Subject: Project name Walker Meadows Lot 25
Project site address 12213 Mayapple Drive
Permit # B20003736 SDP # _____
Other information pertinent to this project _____

MEMORANDUM

RE: *12213 Mayapple Drive, Potential Basement Bedroom*

1 SECOND FLOOR PLAN
SCALE 1/4" = 1'-0"

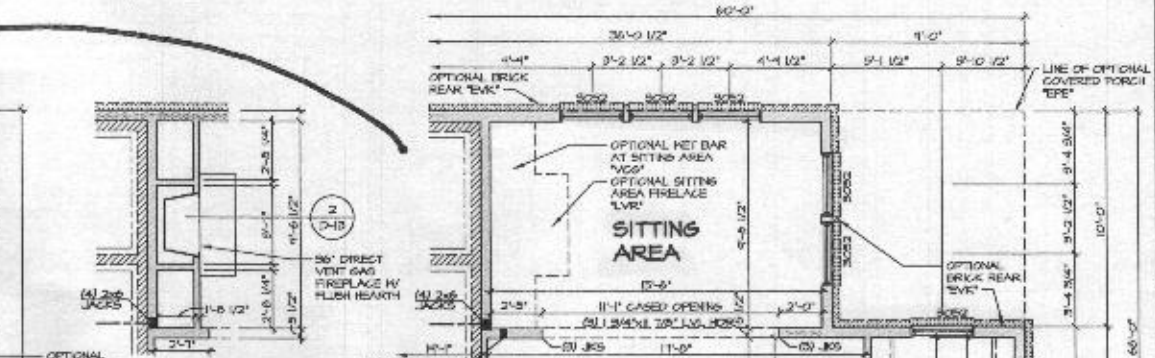
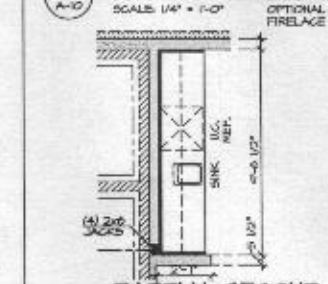
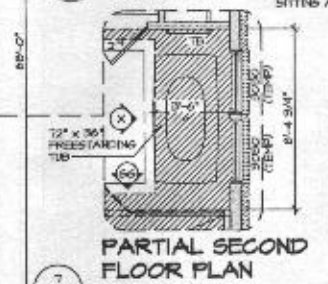
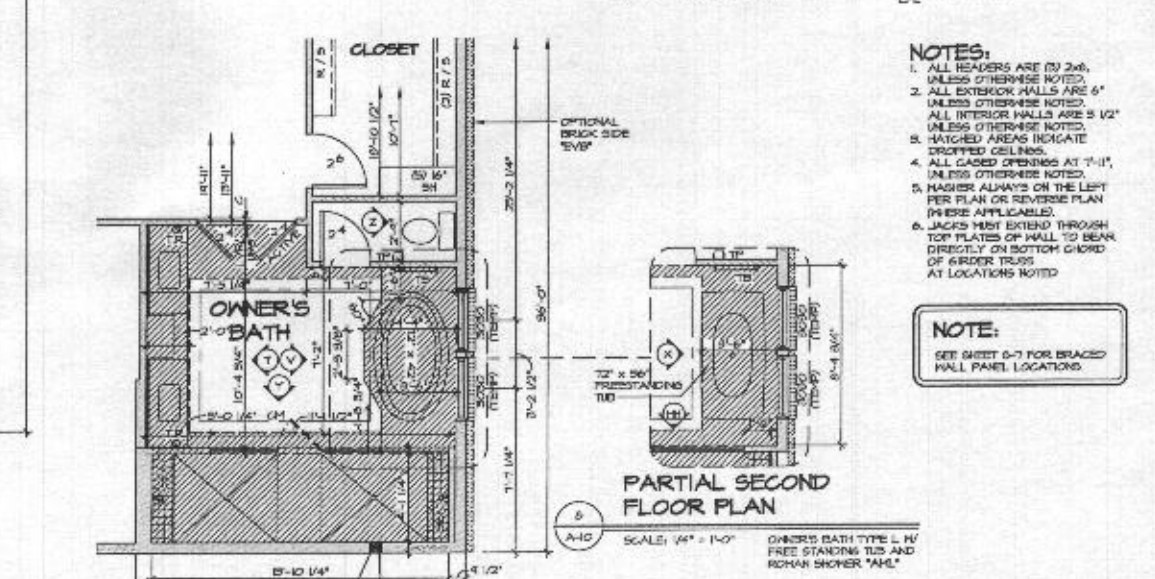
I have reviewed the floor plans in support of Building Permit **B20003736** for a new home at **12213 Mayapple Drive** and noted that there is a proposed full bathroom in the partially finished basement. Please note that this makes it very likely for one or more rooms to be considered bedrooms upon conversion of the entire basement to finished living space and/or installation of an egress window.

The Health Department strongly recommends sizing the onsite sewage disposal system at least one bedroom larger than the existing **five (5)** bedroom design to accommodate a future finished basement. If you choose to only size for the existing design, any future building permit for a finished basement may be placed on hold until the system is upgraded to accommodate the proposed number of bedrooms. This memo will be retained in the Health Department file for future reference.
